ADDENDUM NO. 3

Project Name: **JACKIE ROBINSON TRAINING COMPLEX VILLAS REMODEL (IRC-1914A)**

Bid Number: **2022009**

This addendum is released to provide answers to questions received to date, and to replace pages from the Plan Set as noted in "Attachments".

MECHANICAL/ELECTRICAL PLAN
SCALE: 1/8"=1'-0"

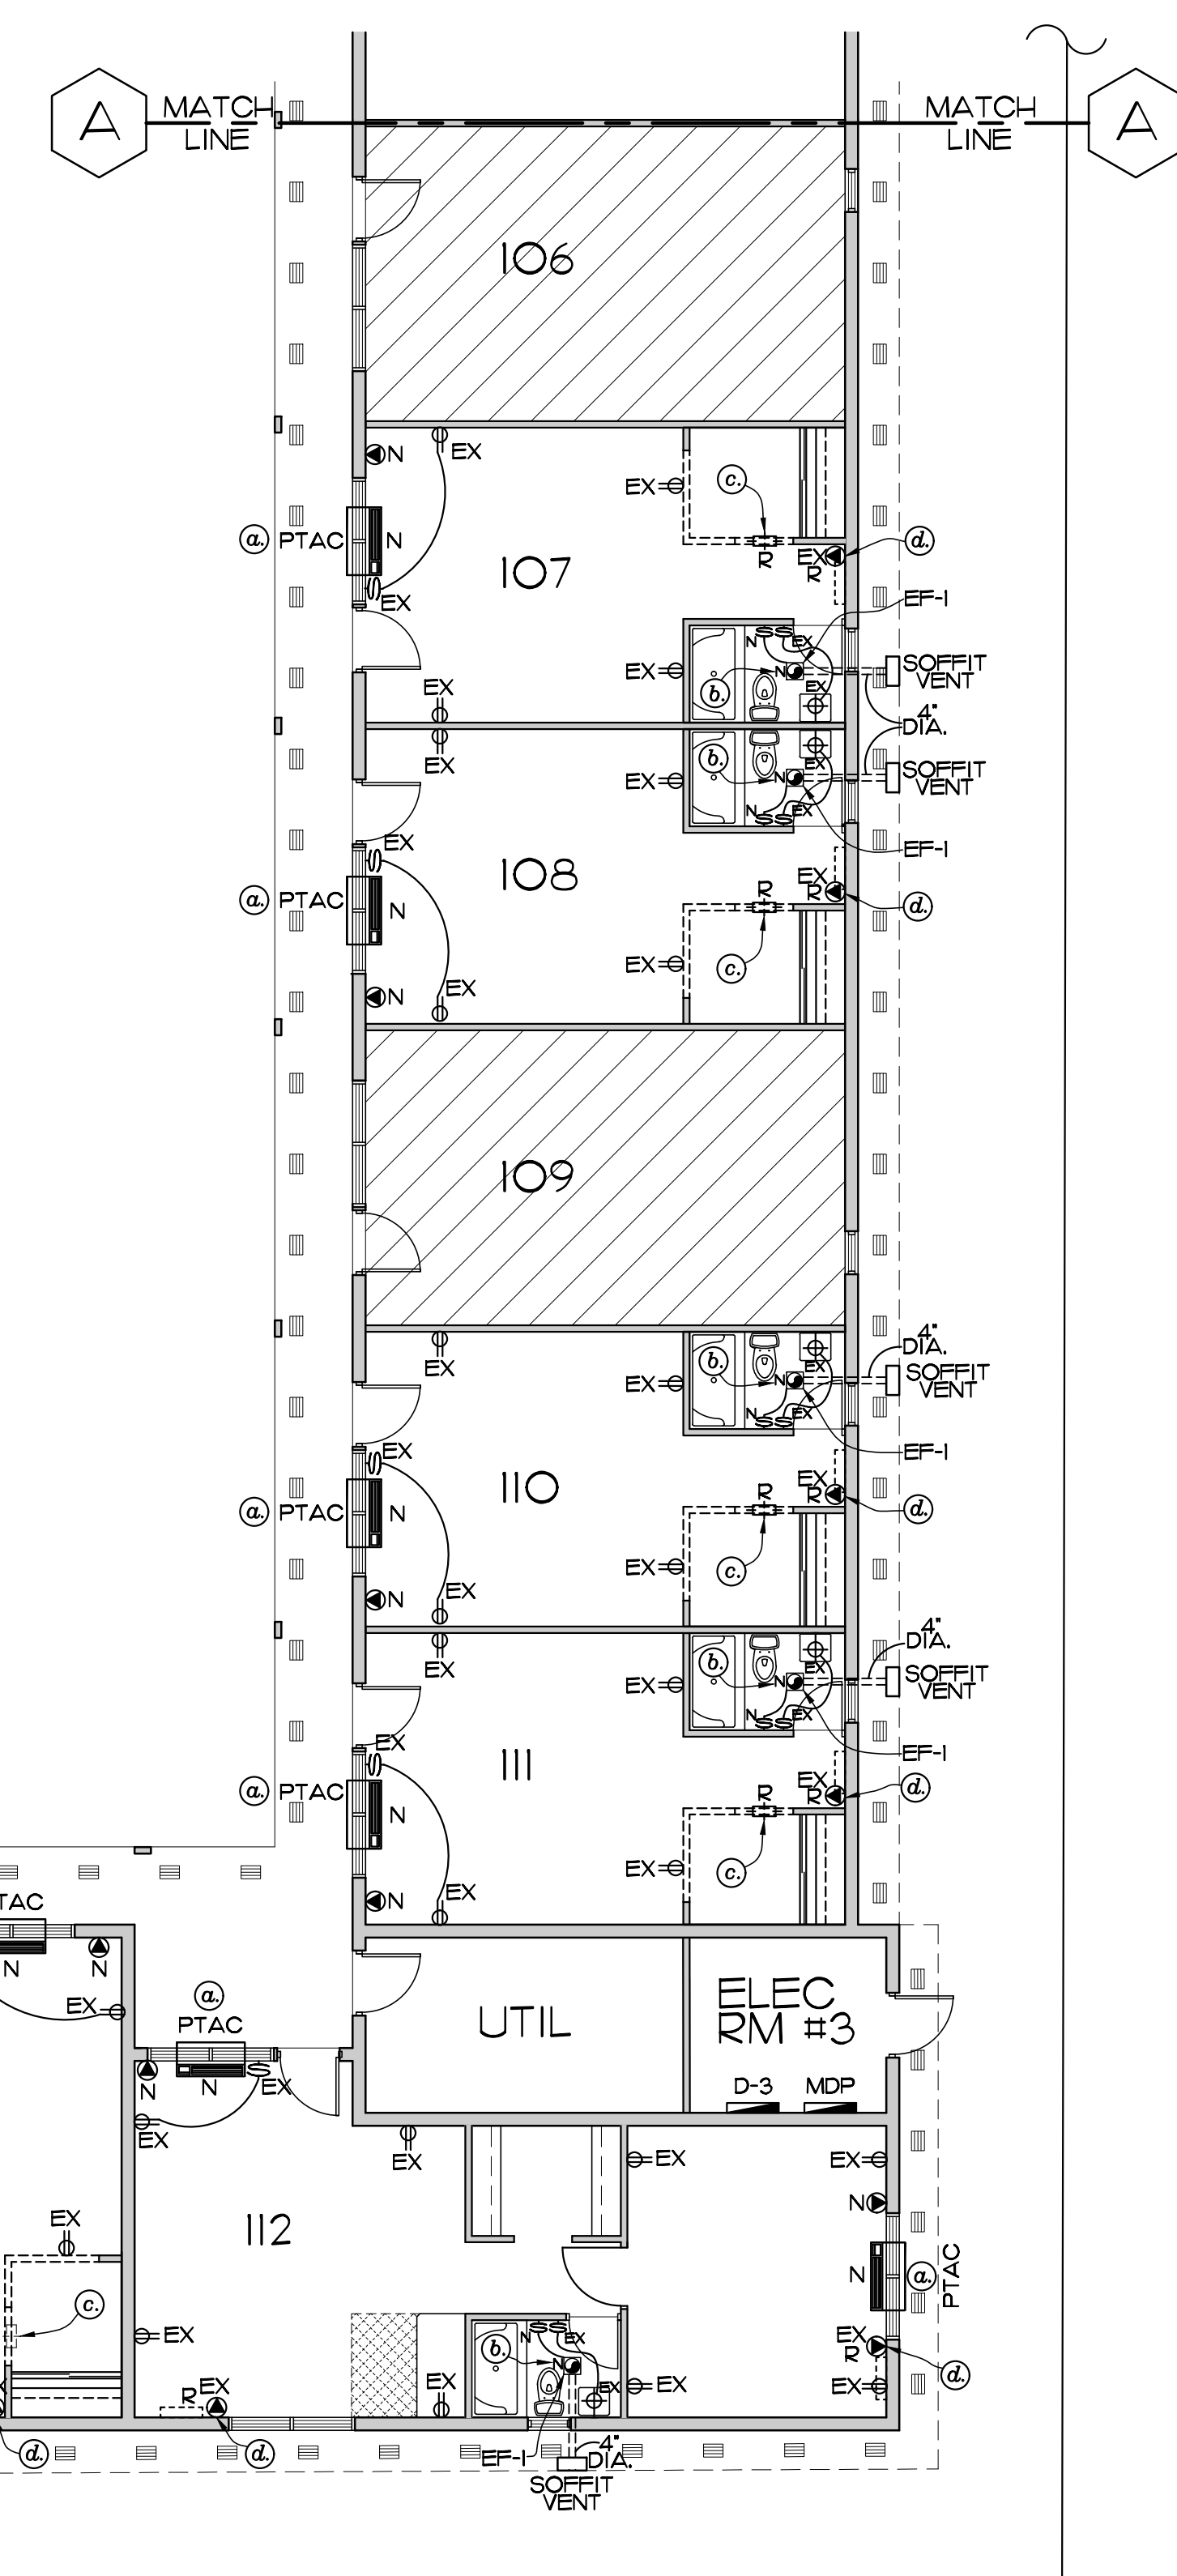
- Architectural plan sheets A-2 thru A-5: The bedroom windows in all of the suites are to remain. These were mis-labeled on plans to be replaced, therefore there will be no change in quantity.
- Sheet A-2 - Additional "r" call-outs have been added to room 107.
- Sheet A-4 – Shading has been added to Kitchen ceilings in rooms 150, 151, 153, and 154. Shading was also added to living room ceiling in room 161.
- Mechanical/Electrical Plans M-1 thru M-4; Trane PTAC unit specified in A/C Equipment schedule is no longer available and has been replaced with a GE PTAC unit, associated electrical notes have been revised.
- Itemized Bid Schedule; Item 1 expanded the description of Mobilization.
- Appendix C - Asbestos Survey Report: Page 4 of report under Drywall System (Texture) the word friable has been replaced with non-friable.
